# **Major revisions to HESS-461-2021: A hydrological framework for persistent pools along non-perennial rivers, Bourke et al.**

## HESS-2021-461: Author changes in response to Reviewer 1

## **HESS-2021-461: Author changes in response to Reviewer 2**

Figure 1 Evolution of pool volume and values of stable isotopes of water in pools with varying water balance components over approximately 4 months of dry season (ET = evapotranspiration, GW = groundwater, A = pool area). Model modified after (Bourke et al., 2021)

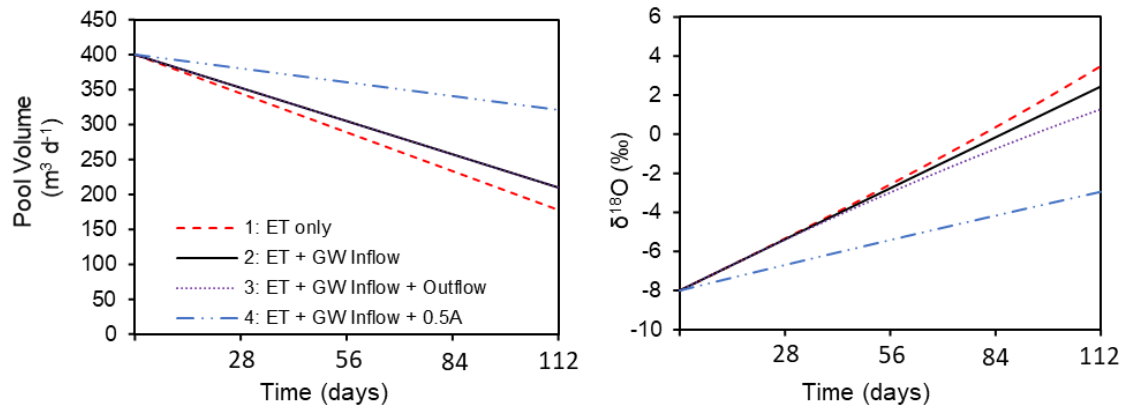
*The reviewer also directs us to Fellman et al., (2011), which we discussed in the early versions of this manuscript. This paper aims to characterize the hydrology of a particular set of pools as controls on dissolved organic matter biogeochemistry. While this manuscript does describe perched and alluvial through-flow pools along river channels, it does not robustly describe the hydrology of these features. It draws conclusions about the hydraulic mechanisms supporting pools based solely on stable isotope values of water (beginning and late dry-season), which are subject to uncertainty that has not been described. In their paper, the water balance of the pools is assumed to consist of inputs from rainfall and groundwater inflow and losses to evaporation. The calculation of evaporative loss from stable isotopic enrichment was made on the basis of a steady state model of evaporation divided by input (E/I). Perched and alluvial through-flow pools are then identified using this ratio (high E/I ratio implies perching). As such, although a subset of the pools are identified as through-flow pools, the conceptual model that underpins the analysis does not account for outflow of water from the pool back into the alluvium (Liebowitz and Brooks, 2008).*

*The stable isotopic enrichment of a pool with an initial volume of 400 m<sup>3</sup> can be simulated using the water balance equations presented in the current manuscript under review (Figure 1 below - now Figure 13 in the paper). The evolution of stable isotopic values is simulated using the approach of Bourke et al., (2021). A perched pool will have no inflow during the dry season and losses to ET only; a through-flow pool will have losses to ET, inflow of alluvial groundwater and loss via outflow (infiltration) of pool water back into the alluvium (ET + GW inflow + Outflow). For a perched pool with a volume of 400 m<sup>3</sup> at the beginning of the dry season, water volume over 112 days will reduce to 178 m<sup>3</sup> with  $\delta^{18}\text{O}$  enriching from -8 to 3.5 ‰. The addition of a groundwater inflow of 0.0002 m<sup>3</sup>/min (0.3 m<sup>3</sup>/d) results in similar end-point values (210 m<sup>3</sup> and  $\delta^{18}\text{O}$  of 2.4 ‰). In this example, using the line of thought presented in their paper, Fellman et al. would have concluded that groundwater in this second pool is not an important component of the water balance. However, over 112 days this groundwater inflow equates to 8% of the initial volume of the pool and may be important for hydrochemical parameters in the alluvial water (or regional groundwater) that have different values than the pool water. Furthermore, alluvial through-flow pools will usually have water losses associated with infiltration to the streambed sediments, which Fellman did not account for. Thus, the inflow of groundwater may be larger than otherwise thought, if it is balanced by infiltration from the pool of a similar magnitude. For example, groundwater inflow of 0.0008 m<sup>3</sup>/min balanced by outflow via infiltration of 0.0006 m<sup>3</sup>/min will result in the same pool water level as a groundwater inflow of 0.0002 m<sup>3</sup>/min, but the isotopic enrichment will be slightly smaller ( $\delta^{18}\text{O}$  of 1.3 ‰). Over 112 days, the groundwater inflow in this third scenario adds up to 128 m<sup>3</sup>, or 32% of the initial pool volume. A fourth scenario where the water balance is consistent with Fellman (ET and GW inflow terms are as per scenario 2), but the pool area is halved (initial volume remains the same) demonstrates that the water balance of the pool and stable isotopic enrichment are sensitive to the pool geometry (volume to area ratio), which Fellman et al. did not report on or consider explicitly in their analysis. Thus, the identification of hydraulic mechanism supporting pools was made on the basis of unsupported assumptions about pool water balances.*

*Their analysis approach, based on an incomplete water balance, led Fellman to conclude that many of the pools studied were isolated from the alluvium water table, but this conceptualization (see their*

Fig 1) is not hydrogeologically robust. All but one of the pools in their paper occur on permeable alluvial sediments with pools 1-12 shown overlying a similar thickness of alluvium. If the pools were not connected to the alluvial (and/or regional) water table, without the presence of a low-permeability layer beneath these pools, the pool water would infiltrate into the alluvium (Brunner et al., 2009) and the pool would not persist. Thus, the inset diagram of “pools isolated from alluvium water table” is hydraulically implausible (as previously discussed in the manuscript).
